ADDENDUM NO. 1

HC Wheatley Institute 3<sup>rd</sup> Floor

## **Project: Wheatley Institute – 3<sup>rd</sup> Floor Renovation**

### **ADDENDUM NO. 1**

**M9243**  
**G0.3**

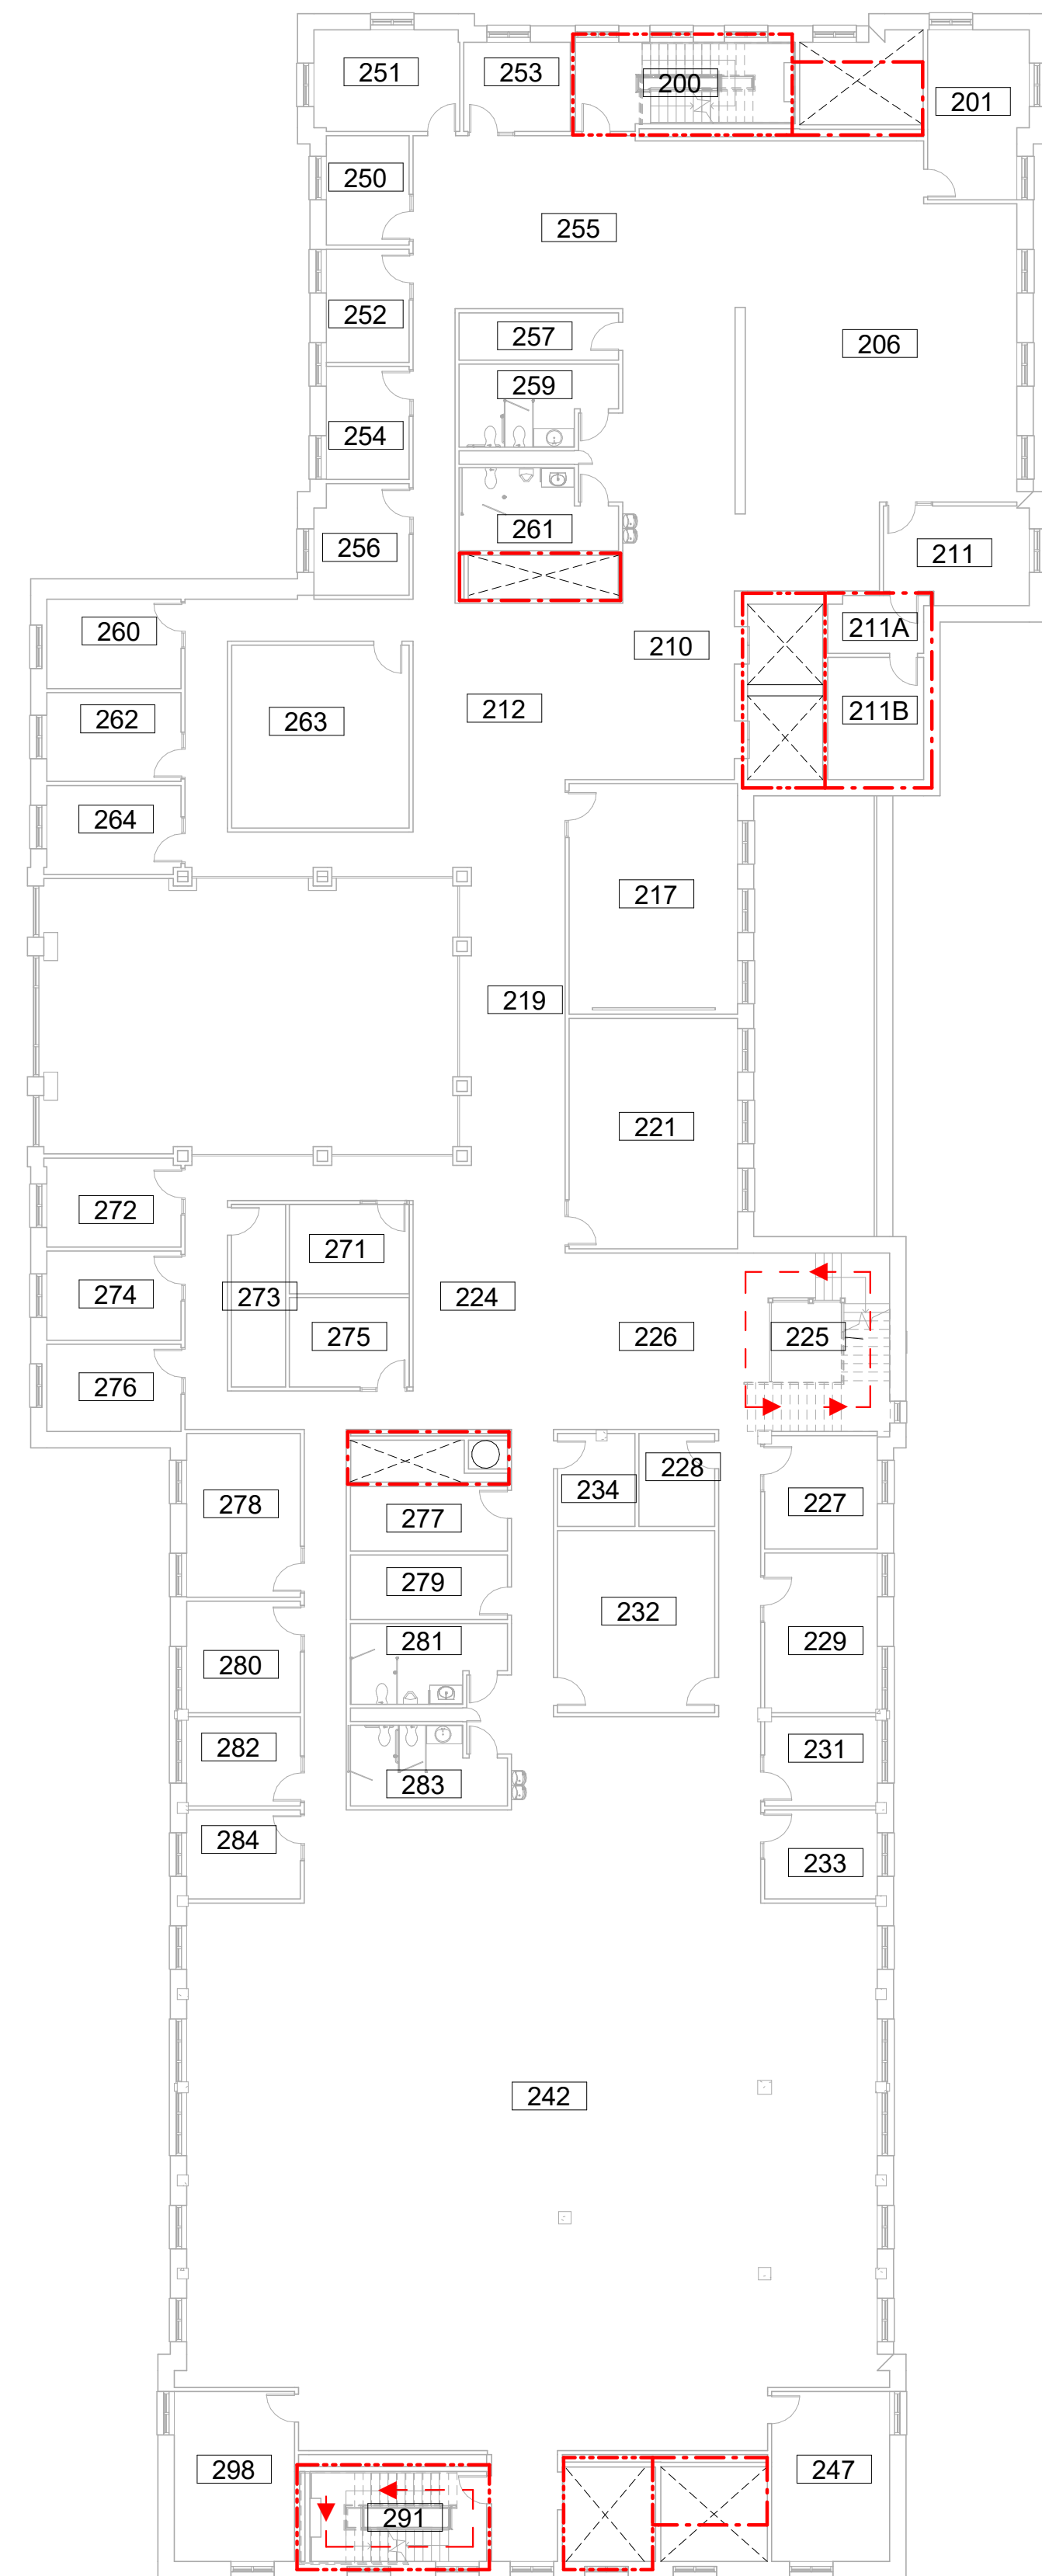
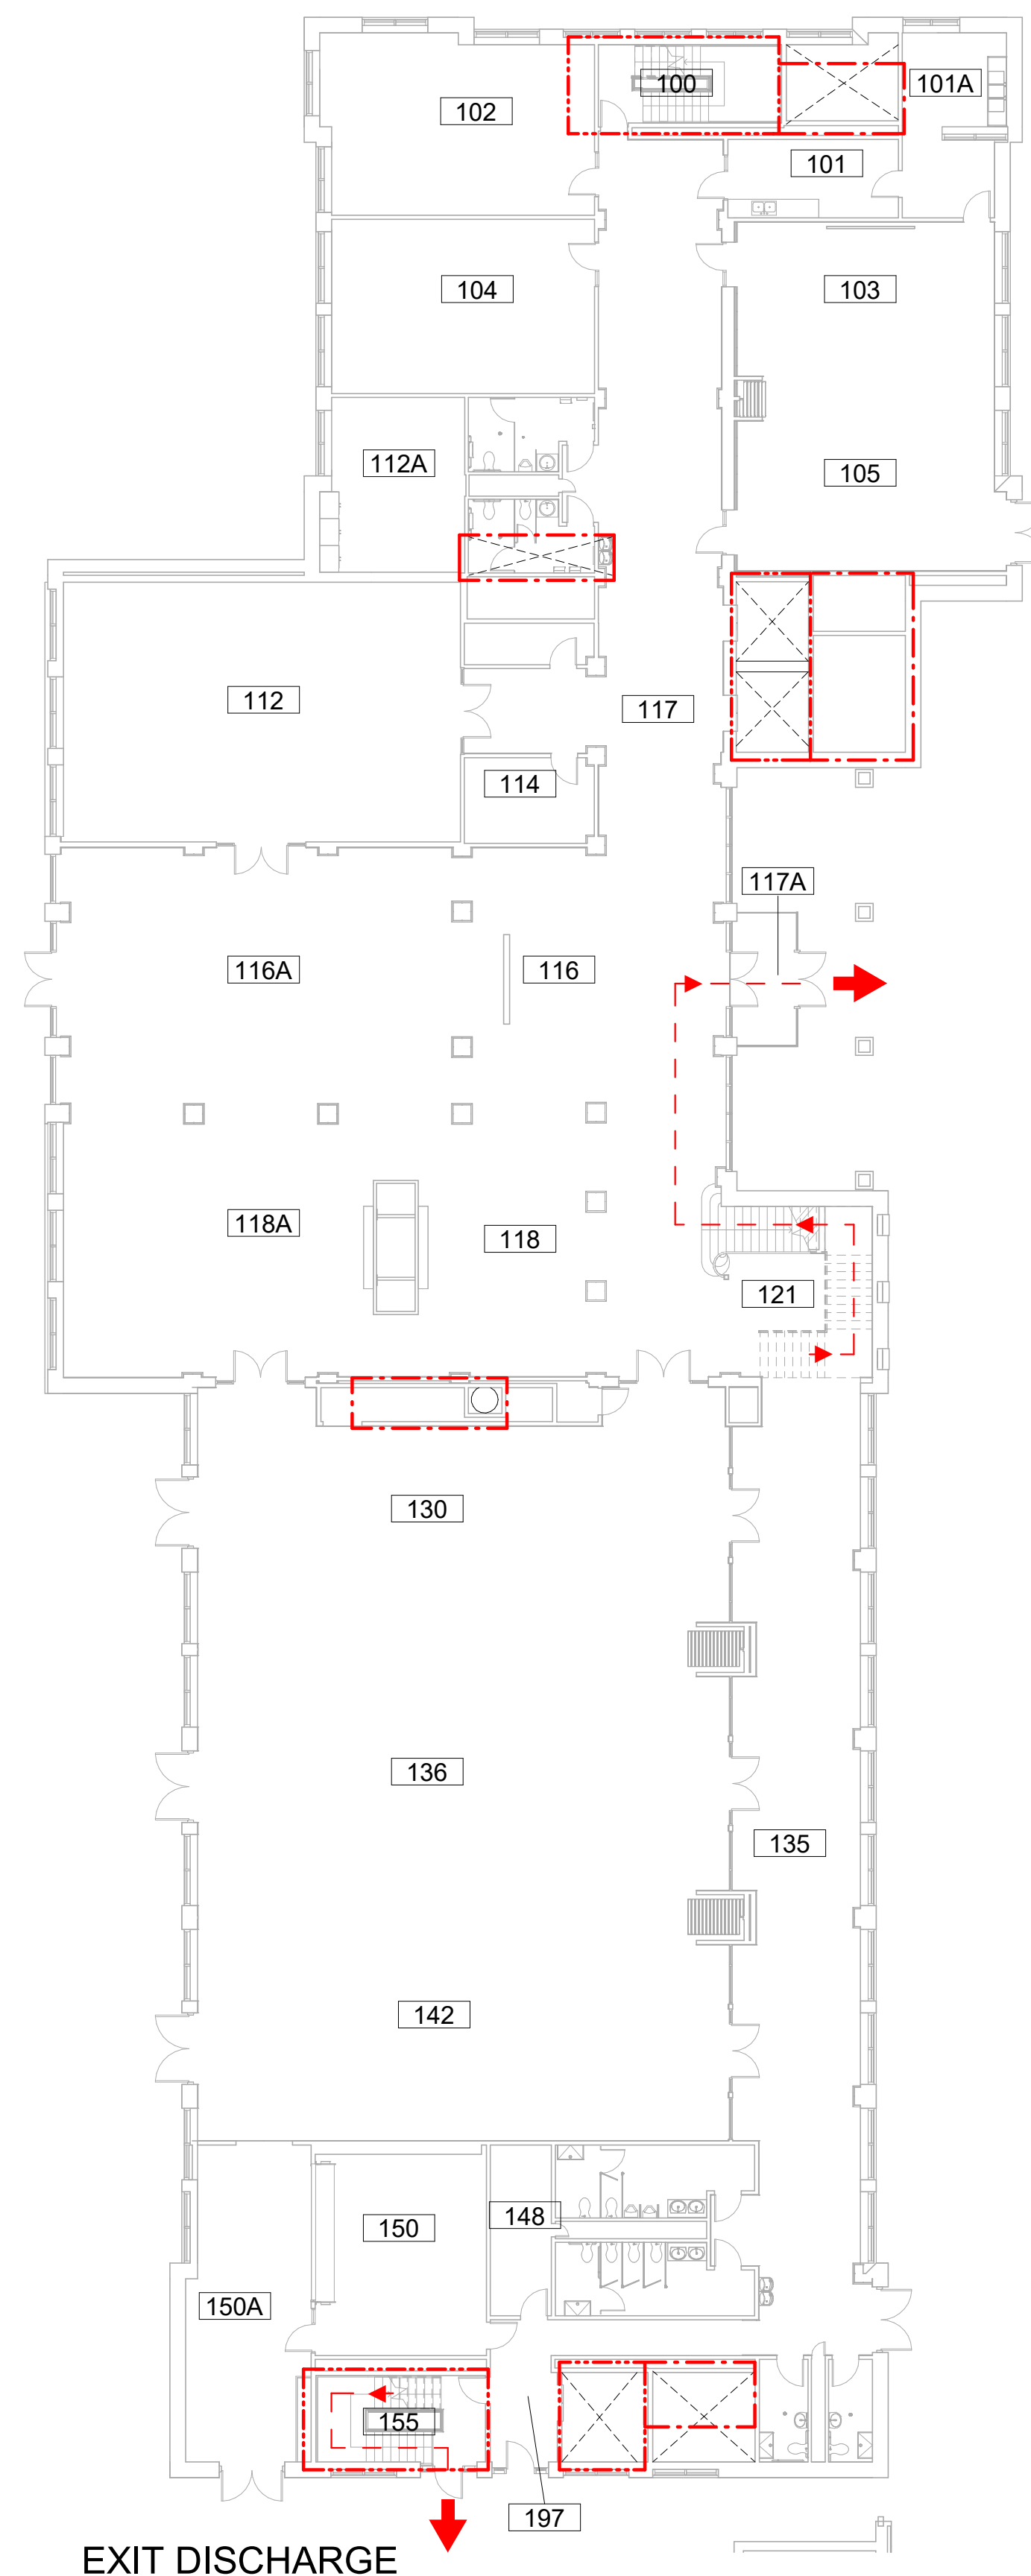
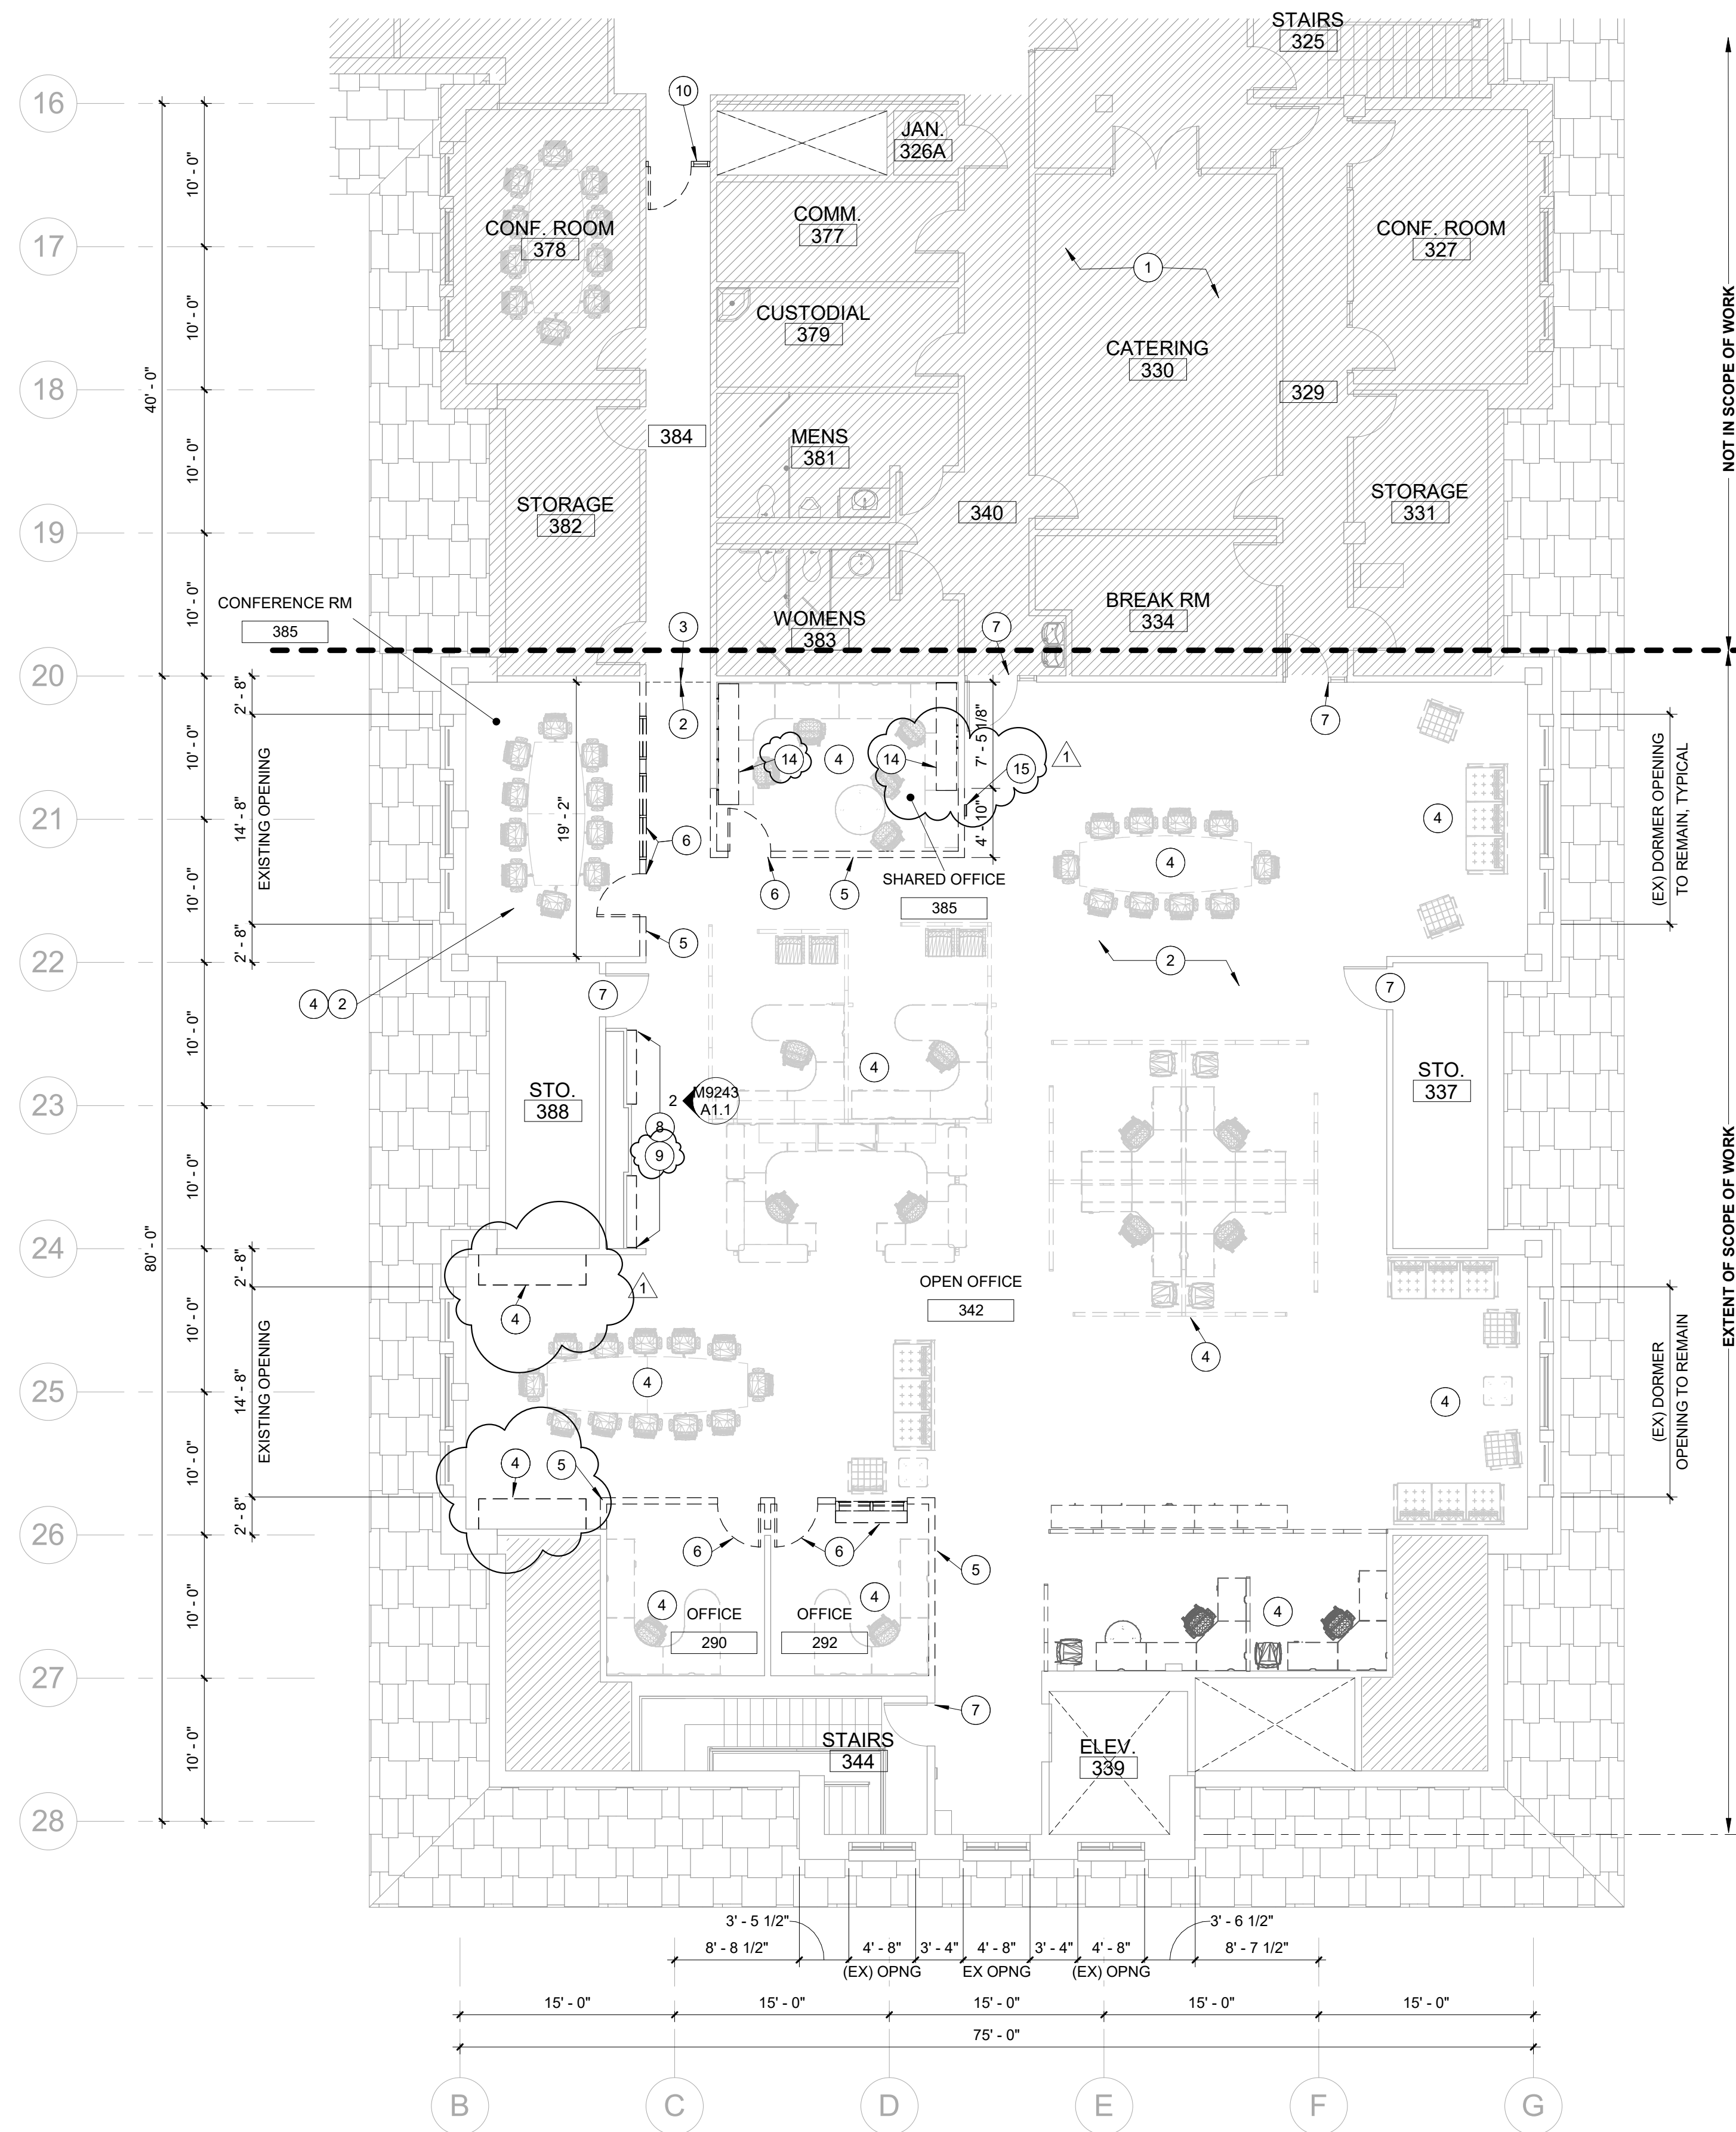
- REMOVE: Assembly type FR3a from sheet.
2. **Sheet G0.3**
  - REVISE: Detail 1 – M9243 Egress Plan to show locations of Fire Extinguisher Cabinet locations within general vicinity of work area.
